Applicant's Answers to Fourth Written Questions

TR020002/D9/FWQ
Examination Document

Project Name:	Manston Airport Development Consent Order
Application Ref:	TR020002
Submission Deadline:	9
Date:	28 June 2019

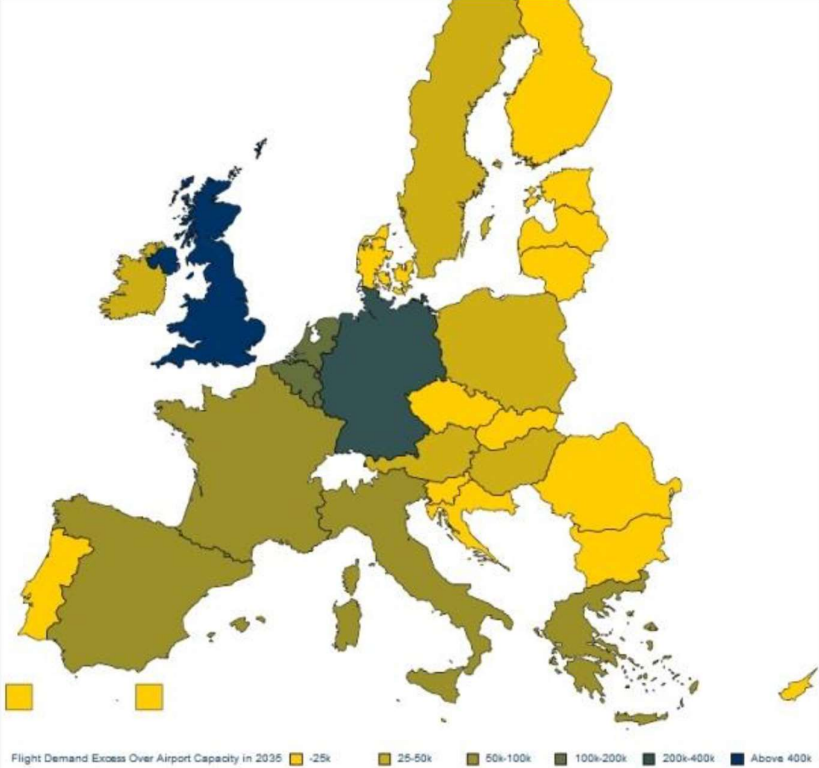
Ref No.	Respondent	Question
		<p>Page 37 Cross-Sections:</p> <p>As a request from Thanet District Council [TDC] Section A was amended to show a tree, making the landscape buffer more robust and consistent with the Landscape Strategy Drawing. This was requested by TDC to ensure the hedgerow buffer around the car park also had trees in it.</p> <p>The north eastern boundary section to the Northern Grass was changed to be an example C (previously example B). This was done to ensure accuracy of the document -. The EIA remains unaffected</p>
